# Sonoma County Planning Commission **STAFF REPORT**

**FILE:** DRH16-0006  
**DATE:** August 3, 2017  
**TIME:** 1:30 PM  
**STAFF:** Georgia McDaniel, Project Planner

**Appellant:** Valley of the Moon Alliance (VOTMA)  
**Applicant:** Flora Li for Tohigh Investment  
**Owner:** Tohigh Investment SF LLC (Tohigh)  
**Location:** 900, 1200, 1202, and 1204 Campagna Lane, Kenwood  
APNs: 051-260-014 Supervisorial District No.: 1  
**Subject:** Appeal of Design Review approval for a new Inn, Spa, and Restaurant  
**PROPOSAL:** Request for final Design Review approval for an inn, spa, and restaurant on a 51.9 acre parcel.

Uphold the October 19, 2016 Design Review Committee approval of the revised project design and site plan modifications with two minor changes required by the Open Space Conservation Easement.

**A**  
1 MAIN HOUSE SITE LAYOUT - CONCEPTUAL DESIGN  
SCALE: 1" = 20'

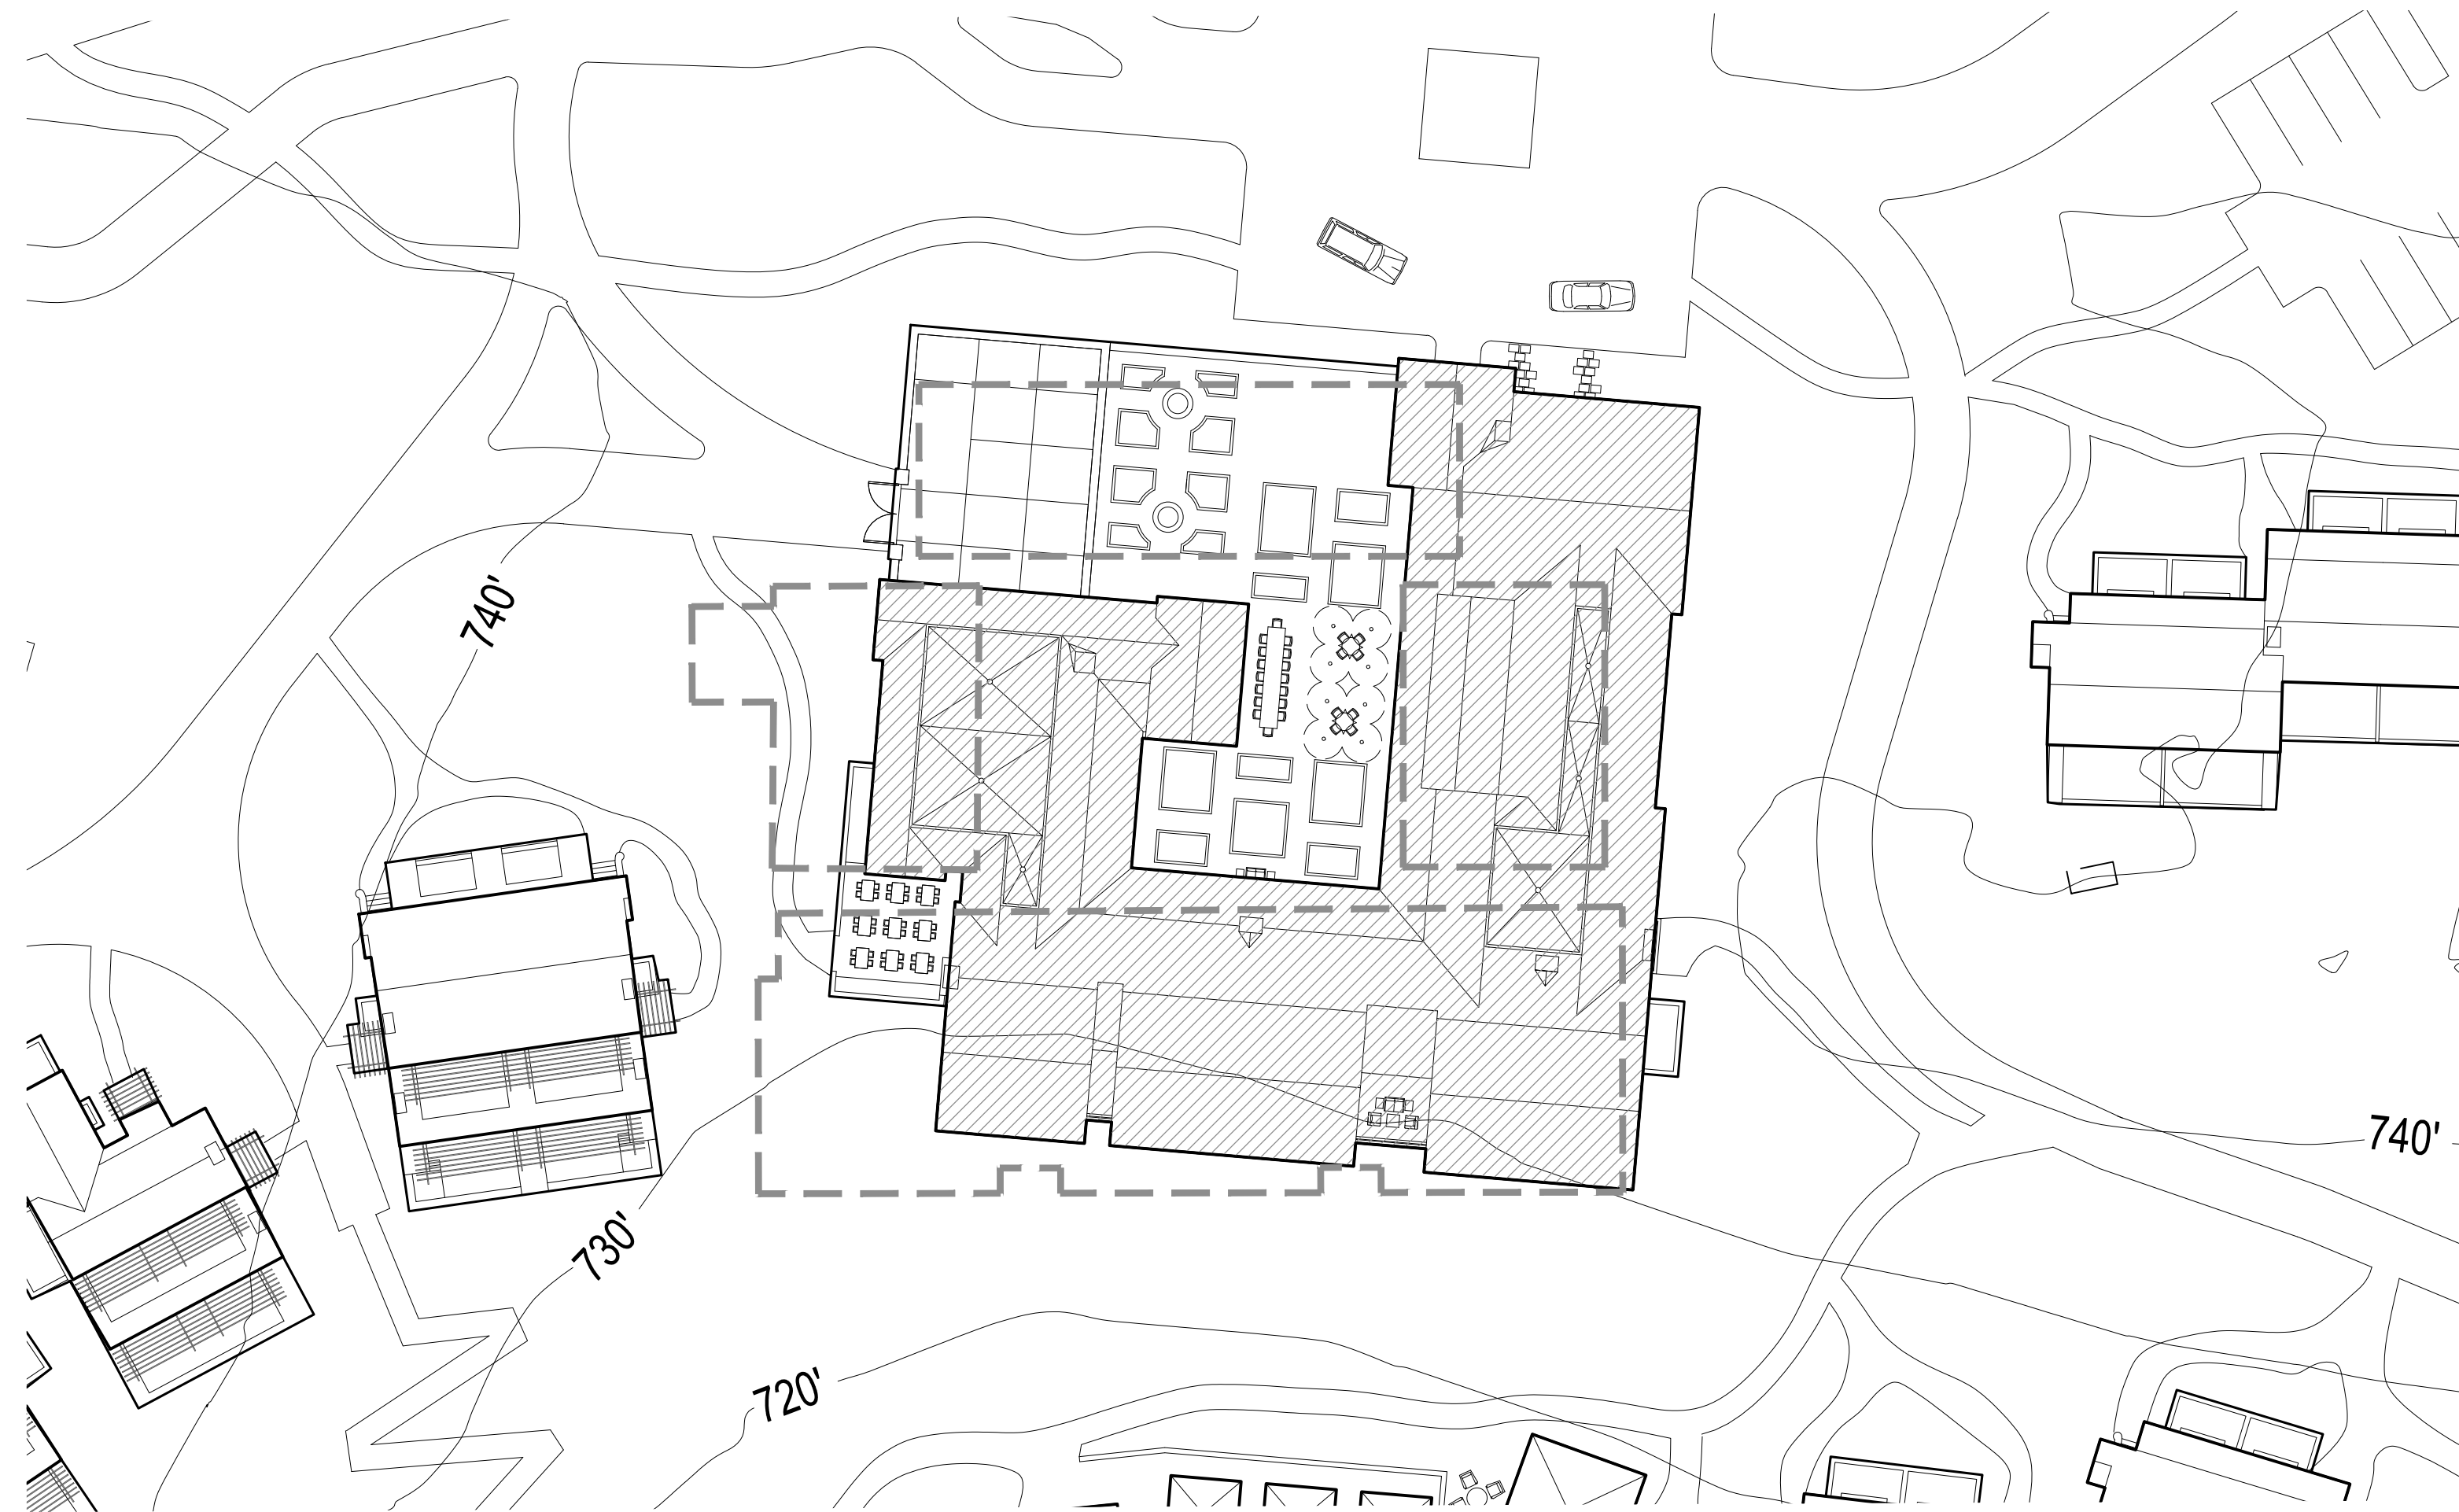
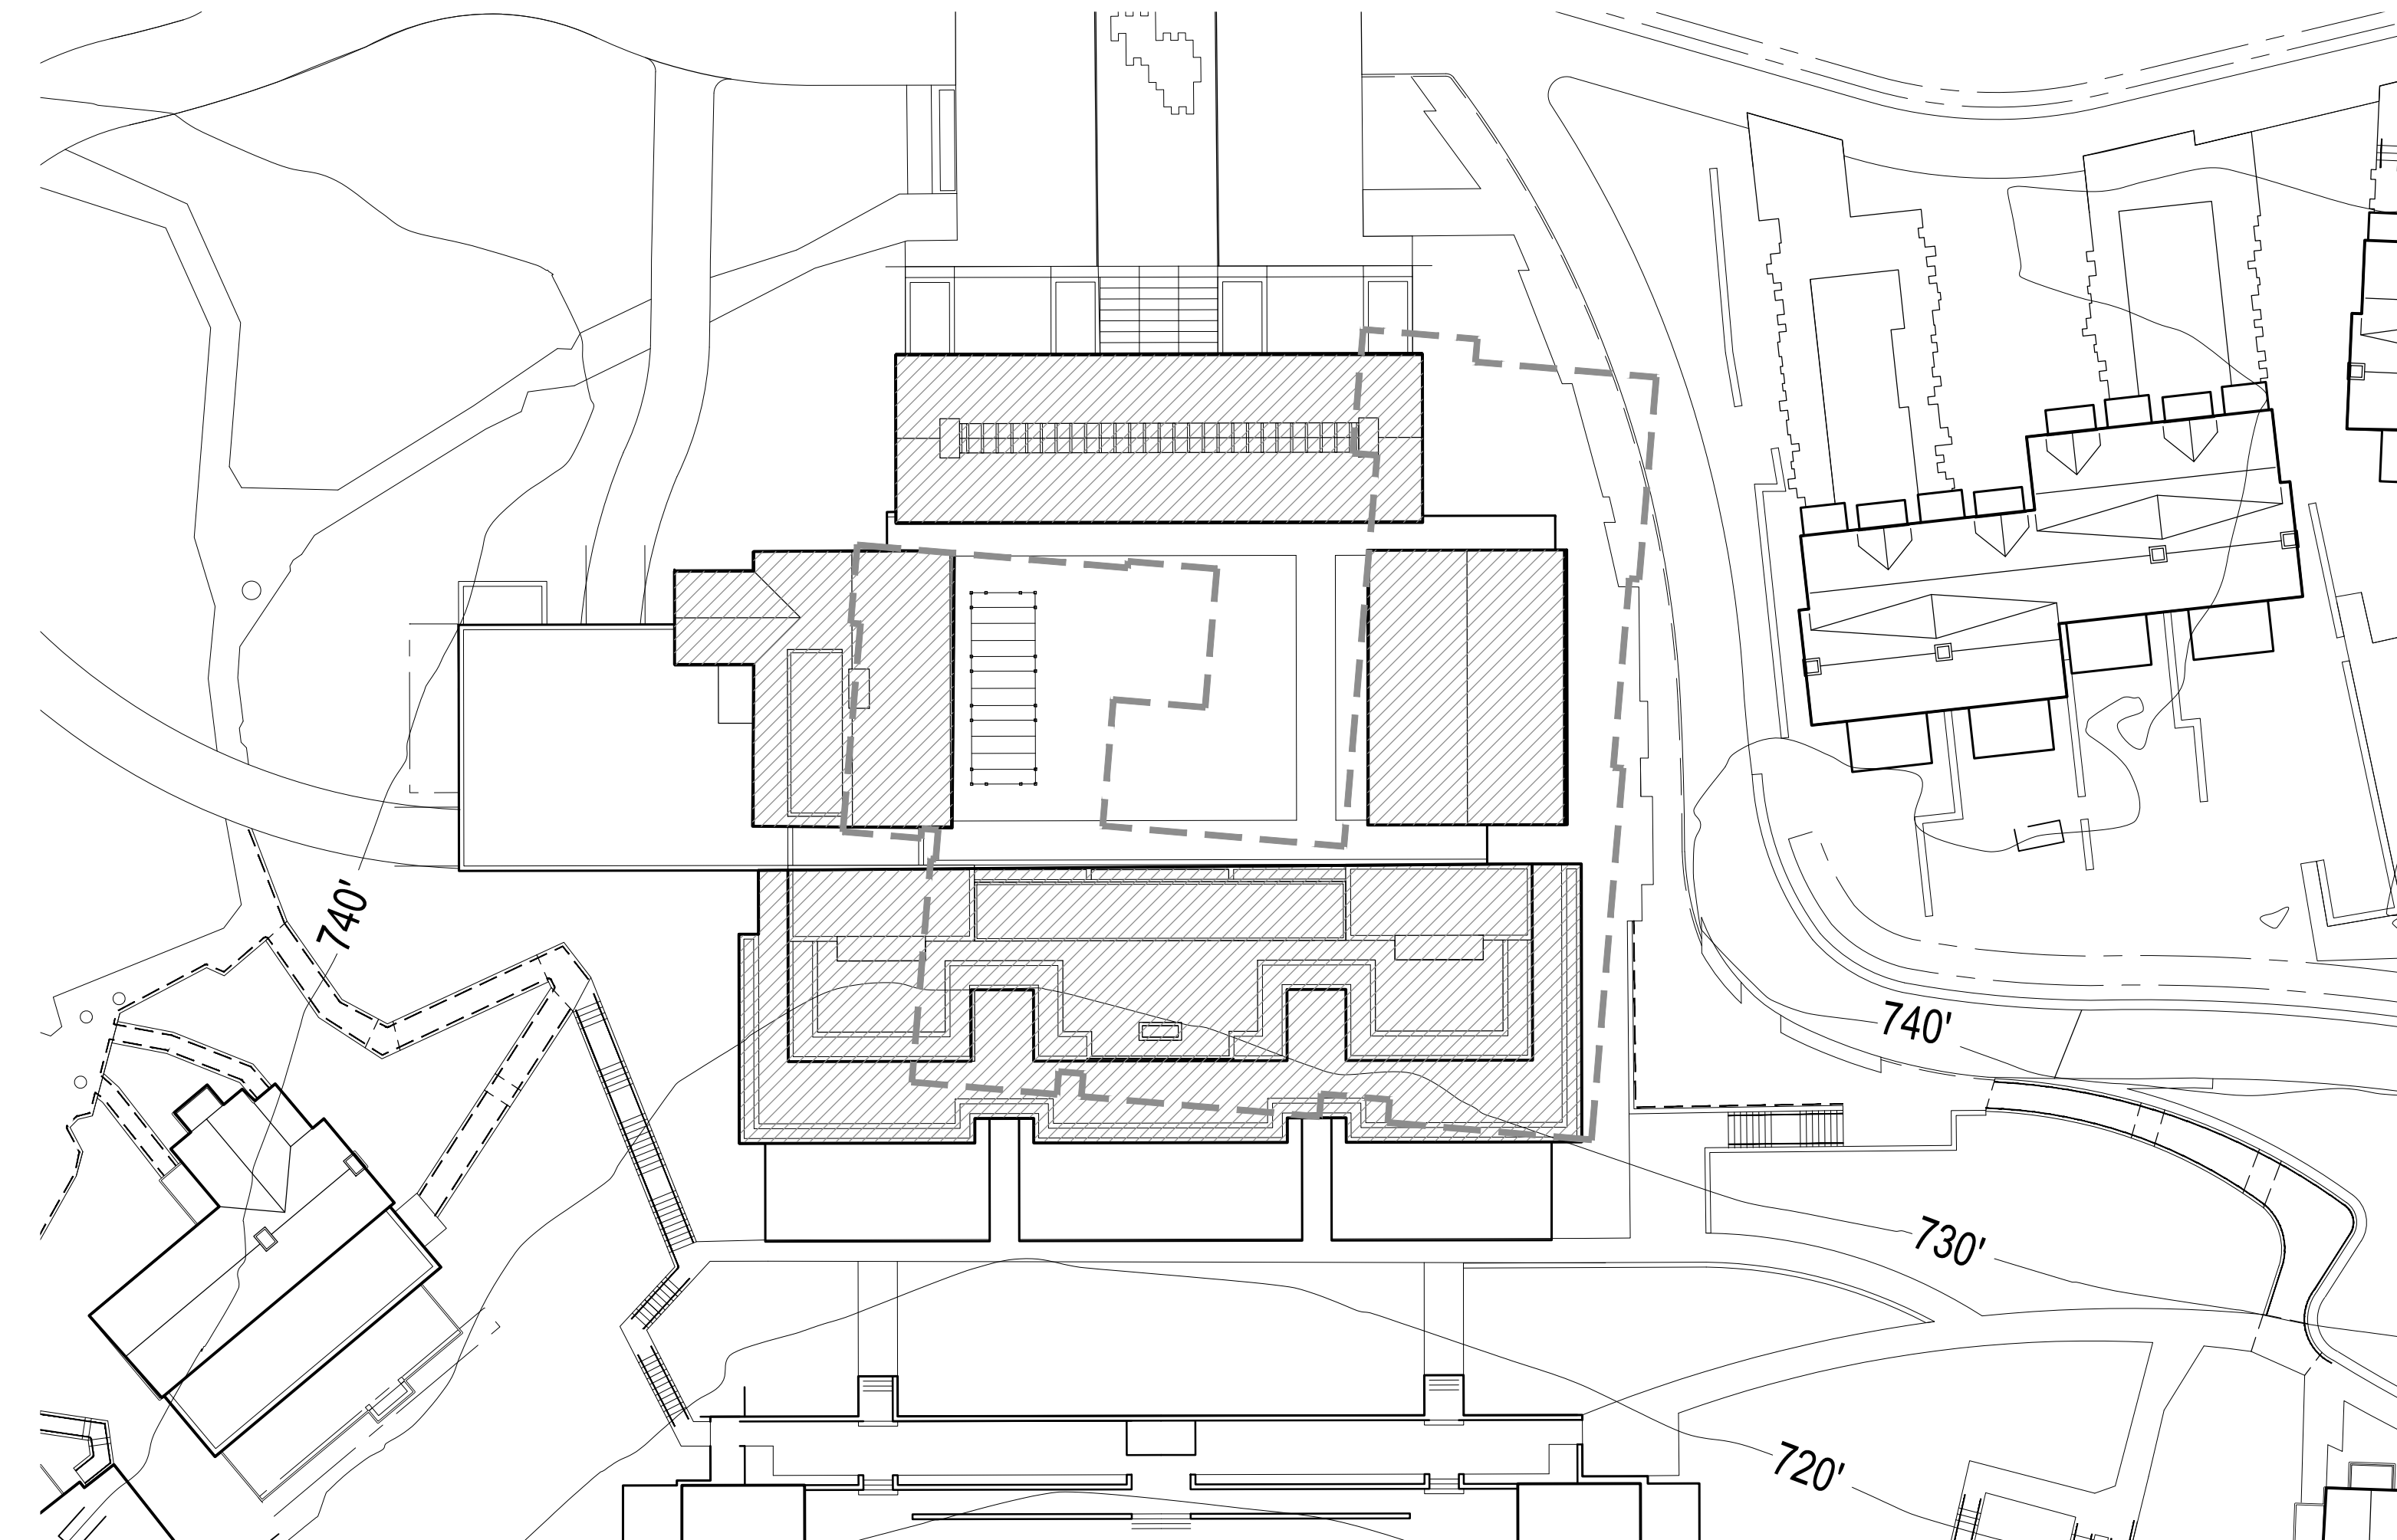
Exhibit 3.0-10 clearly shows an overhanging roof on the southeast facing side of the Inn. That same exhibit does show some sort of very small terrace on a portion of the northwest facing side of the Inn. Tohigh explained the decision to eliminate the south roof and replace it with a terrace/bar hot spot as one driven by the desire to

A roof garden would replace the solid mass of the pitched slate roof of the conceptual design to better blend the building into the landscape and reduce the visibility from the valley below. The roof garden would contain trees and plantings, softening the appearance of the building and obscuring the upper portion of the structure.
